WEBSTER SCHOOL DESIGN DEPARTMENT RECOMMENDATIONS

Project #3025876

JUNE 8, 2018

Design Departure Advisory Committee Report and Recommendations

Exhibit 3 Proposed Lot Coverage

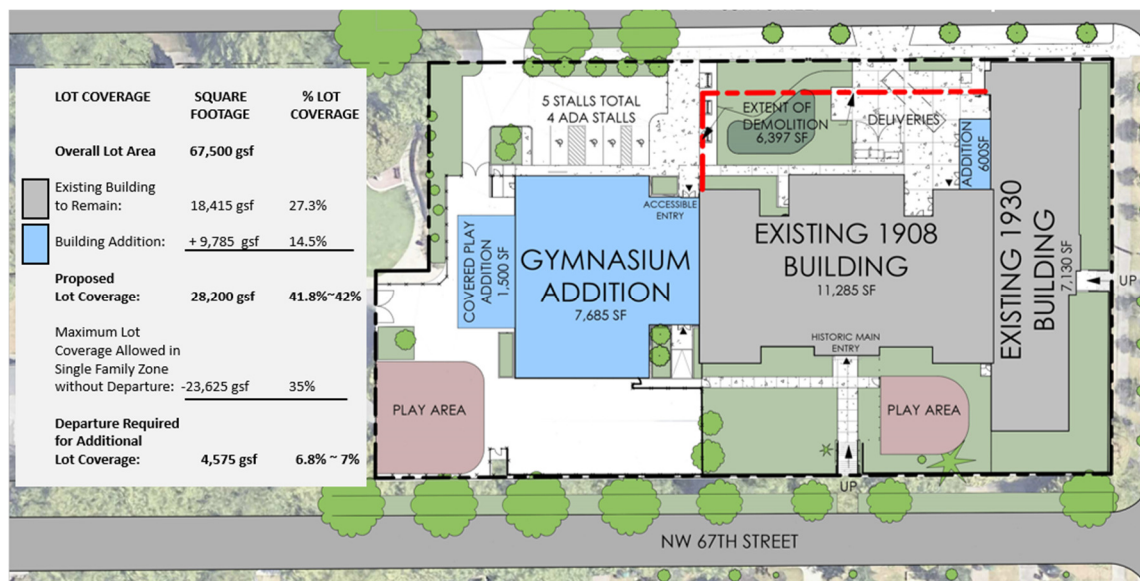
Departure Requested: 7% additional lot coverage.

The maximum lot coverage in a single family zone without a departure is 35%. The existing school already covers approximately 37% of the lot. The proposed demolition would remove approximately 9% of the existing lot coverage, and the new gymnasium addition would add approximately 14.5% lot coverage for a total of 42% lot coverage. While the departure is for 7% lot coverage greater than allowed, the noticeable change will be 5%. The committee did not express any concerns specific to the lot coverage but wanted to be sure they discussed the use of the open space in relation to Webster Park with departure #3: Setback (noise).

The Design Team is proposing adding a gymnasium and covered play area which will result in 42% lot coverage. This will only add 7% coverage of the allowable 35%.

Exhibit 4 Proposed Height

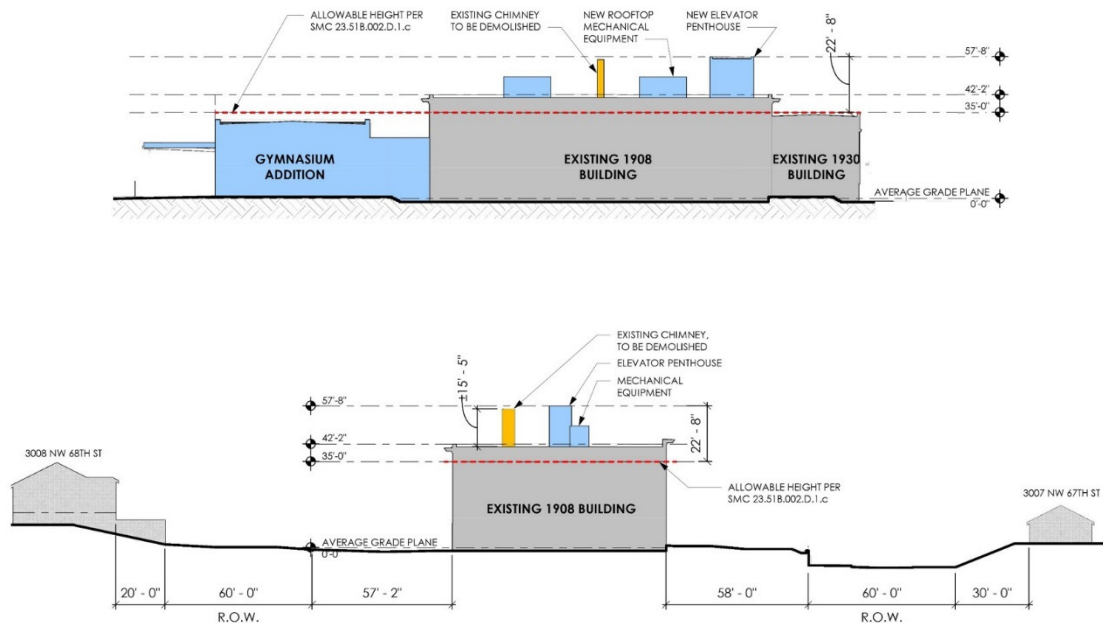
Departure Requested: 23 ft. above the 35 ft. height limit.

Mr. Vos asked about the rooftop elevation and questioned if the height is too excessive and whether a stairwell entry is adequate instead of having an elevator.

Departure 2 (Building Height), gather information about the elevator configuration, provide studies or justification on why a decision was made to install an elevator instead of a stairwell;

Mr. Ho shared that the discussion from the last meeting was about the elevator penthouse equipment. He noted that the penthouse will be located on the east side to accommodate the multiple heights of the 1930 and 1908 building. The request from the last meeting was to provide options to access the elevator and he showed a diagram that presented a study of elevator versus the stair access. The stairway option could lower the height under 5 ft. from 57.8 ft. to 53 ft.

Mr. Ho mentioned that they would prefer it to be less, but the elevator manufacturers require certain height requirements for safety. Mr. Becker added that the elevator will be used throughout the building and it is ADA. The elevator will allow mechanics to safely and quickly repair and replace the mechanical penthouse equipment.

Exhibit 7 Location of Off-site Bus Loading & Unloading on NW 68th Street

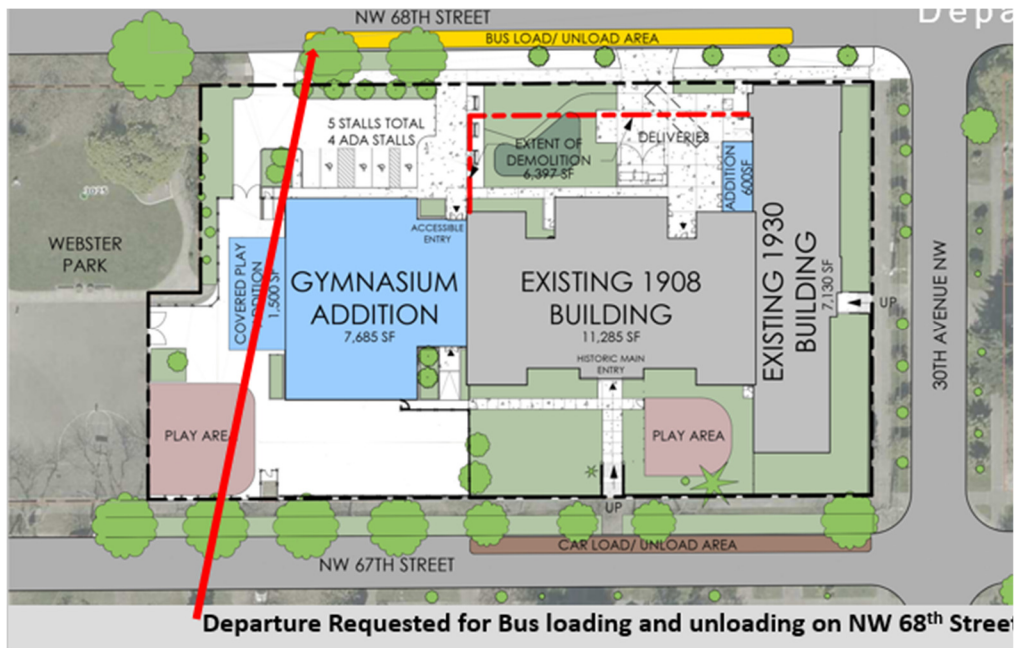
Departure Requested: To locate on-street bus loading on NW 68th Street.

Departure 4 (On-street Bus Loading & Unloading) : (i) Provide case studies and examples about other area schools dealt with similar set-up. (ii) Present other bus-loading location options. (iii) Provide maps that show routing options for how buses and cars will enter and leave the neighborhood.

Mr. Ho mentioned that the School District is proposing to locate bus loading on 68th because of the new accessible entry. There was a request to better understand why they can't use 30th and 32nd, and the team would not recommend that route due to proximity to the school, grade change, and no supervision for bus drop off. The primary issue along 67th is accessibility.

Recommendation 4 – That the departure to allow off-site bus loading & unloading on NW 68th St. be GRANTED as requested by the Seattle Public Schools without modifications and with the following conditions:

Exhibit 8 On-Site Parking Stalls

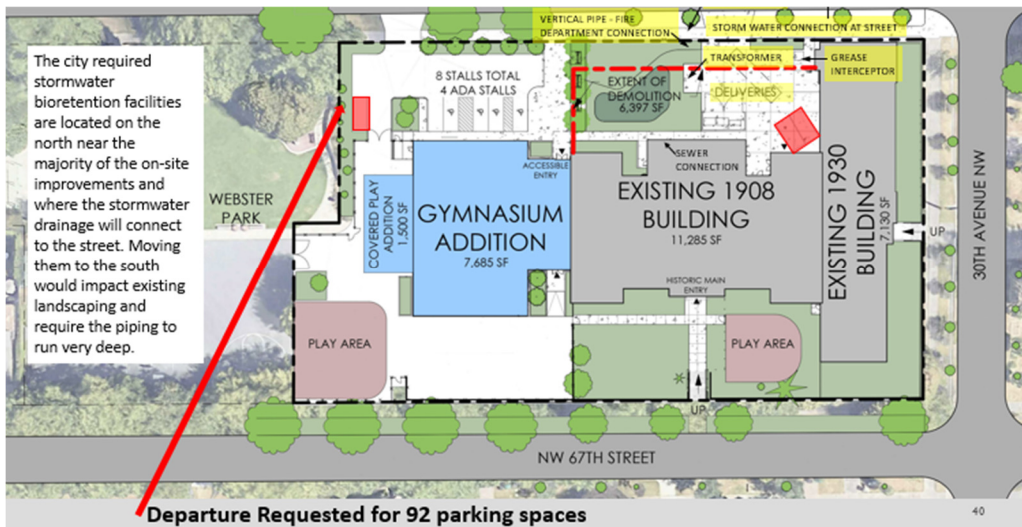
Departure Requested: to allow for 92 parking spaces less than the code required parking to be provided on-site. [100 required stalls – minimum of 8 proposed stalls = 92 departure stalls requested]

Departure 5 (Off-street Parking), present a diagram or visualization on how parking would look within a 600' of the school property and an analysis if 5 or 10 additional parking spaces can be added on site for daily use.

To make the project as efficient as possible, the team was able to add three more stalls for a total of eight. The departure request is for 92 parking spaces.

Recommendation 5 – That the departure to allow less than required off-street parking be GRANTED as requested by the Seattle Public Schools without modifications and with the following conditions:
